**AMENDED
STATEMENT OF JUSTIFICATION
CSP-20002
Terrapin House**

February 4, 2021 (amended in response to SDRC and comments from City Planning Staff)

**Re: CSP-20002 – Terrapin House
Point-By-Point Response Letter
SDRC Date: November 30, 2020**

SITE & LANDSCAPE PLAN

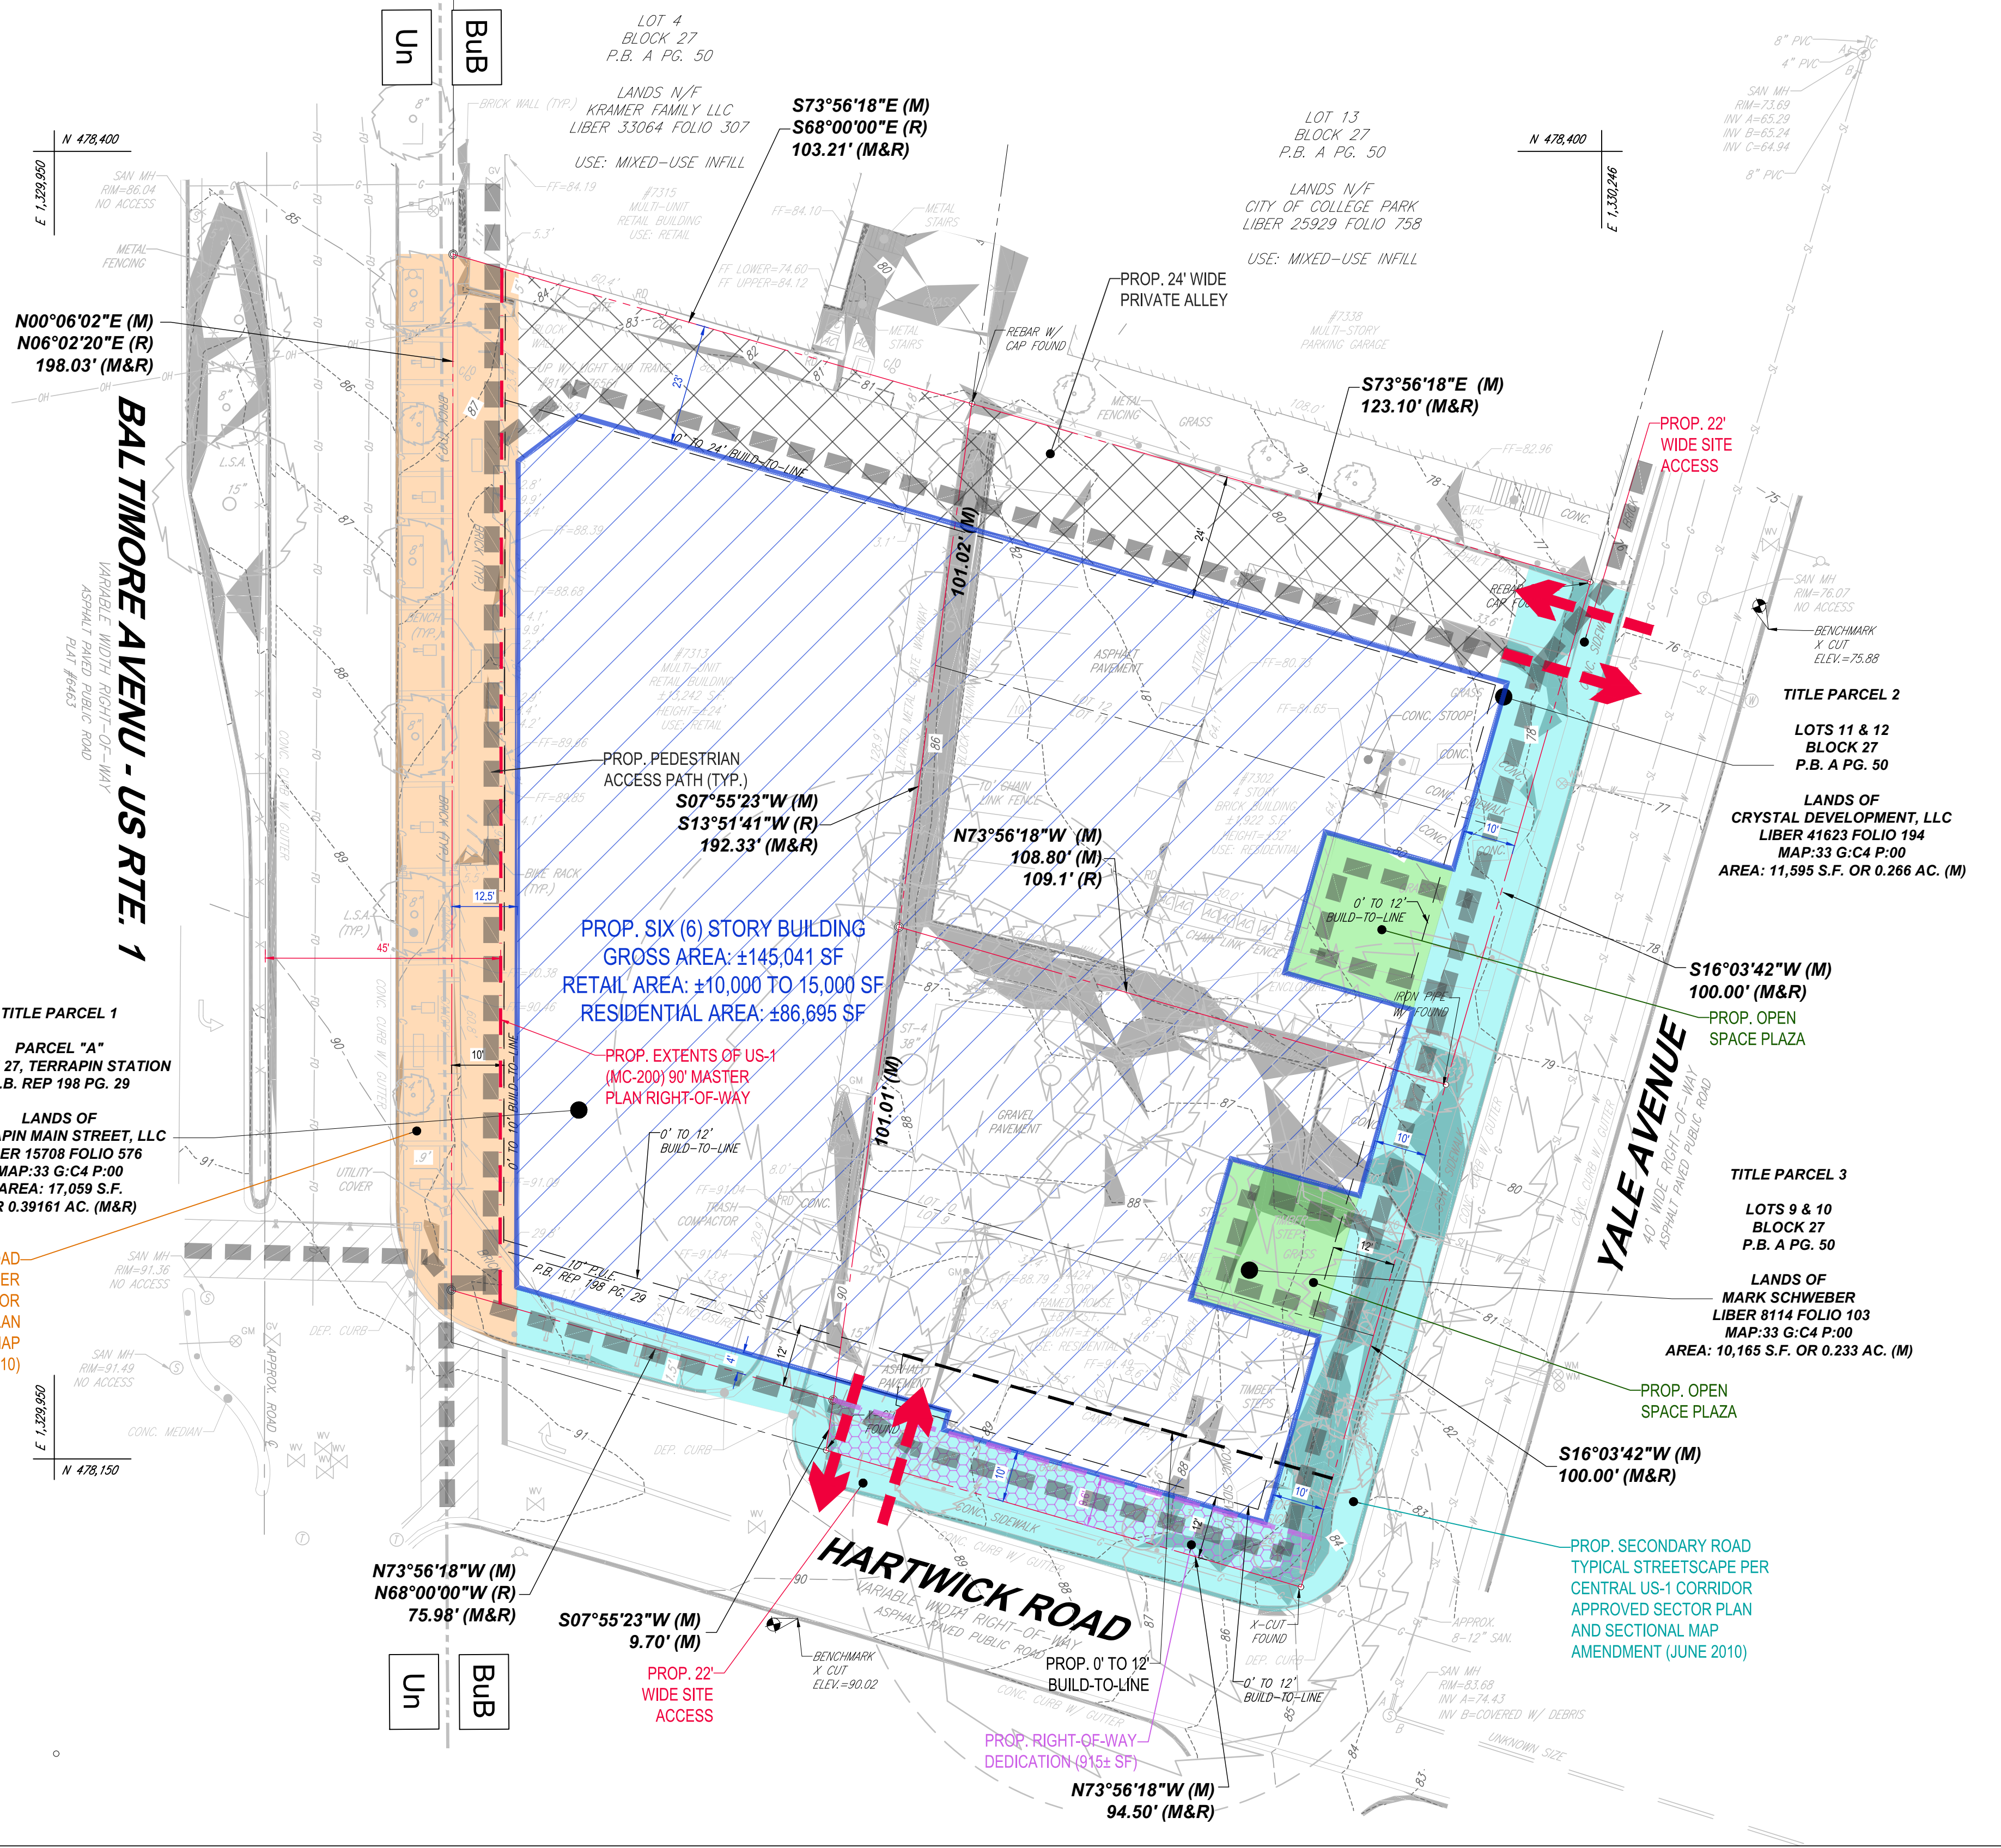
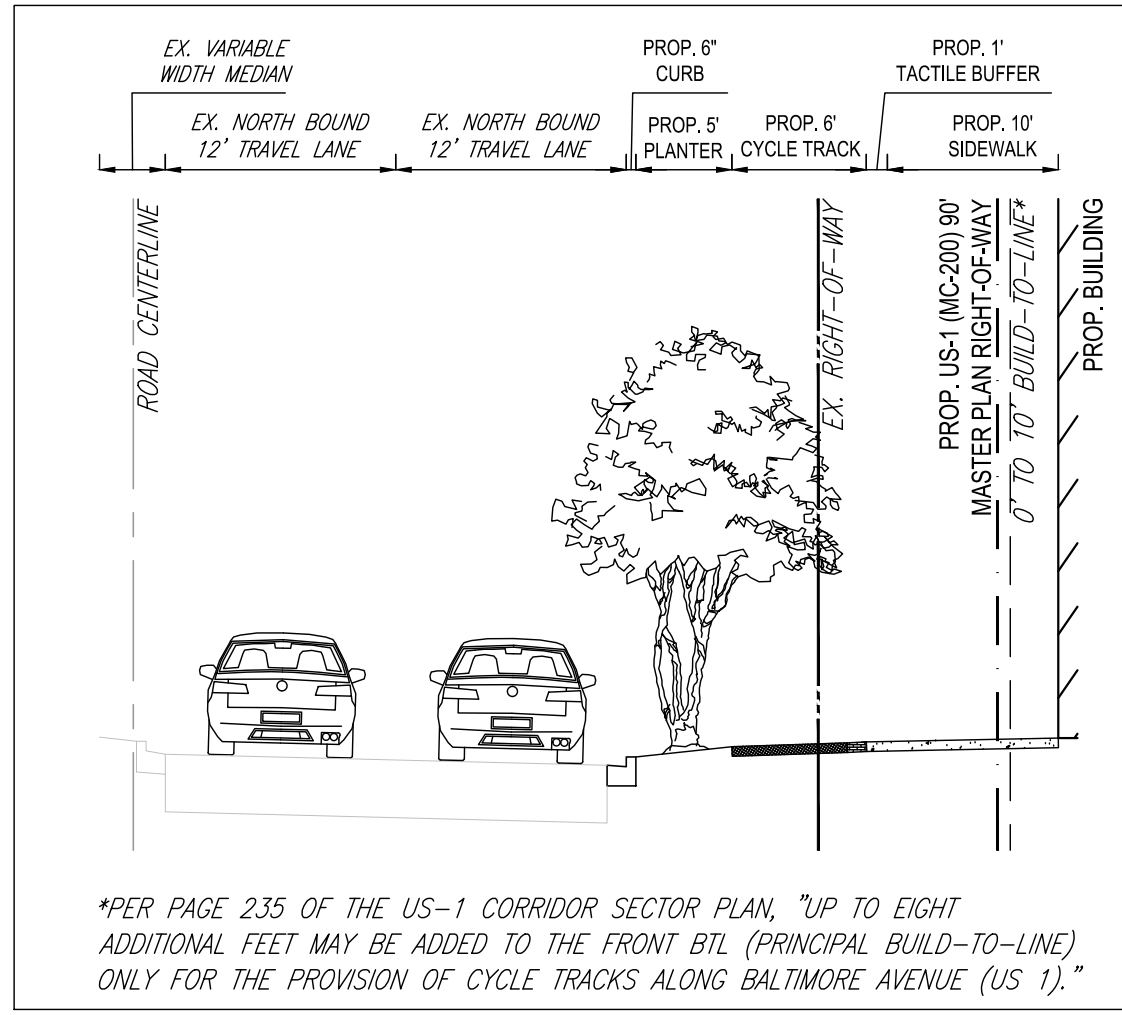
- **Conceptual Pedestrian access to all areas within the subject site and to adjacent properties.**

3. The CSP should show the master plan right-of-way US-1 (MC-200), although dedication is not required at this time. Right-of-way widths for Yale Avenue and Hartwick Road will be determined at PPS stage.

Urban Design:
Need Illustrative plan.

City of College Park:
Will not support CSP as they feel DSP is correct way to rezone in the DDO, would like to see the Willow Oak on the corner saved, will require dedication on Hartwich and US 1.

Response: Where possible, CSP-20002 has been revised to locate conceptual pedestrian access; to include areas along the US 1 frontage for a proposed primary road typical streetscape pursuant to the Central US 1 Corridor Sector Plan; sidewalk access and possible area of dedication along Hartwick Road; and area along the frontage of Yale Avenue for a proposed secondary road typical streetscape pursuant to the Central US 1 Corridor Sector Plan.

Response: The ultimate ROW for US-1 (MC-200) is accommodated within the existing right-of-way. Further evaluation of the same will be done at the time of PPS. The existing variable width right-of-way is depicted on the CSP

Response: An Illustrative Plan is included with the re-submittal package.

Response: Since SDRC, the applicant understands that the City Planning Staff and MNCPPC Technical Staff have met and have explained that Section 27-548.26(b)(2)(C) allows an applicant to file a conceptual site plan that requests changes to the underlying zone. Moreover, since SDRC, the applicant (and its development team) have had a couple of virtual meetings with City Planning Staff and had made a number of revisions to the originally submitted CSP to provide more detail to the conceptual plan and show how the development could be conceptually designed given certain development district standards related to Building Form and Architecture within the Walkable Node Character Area.
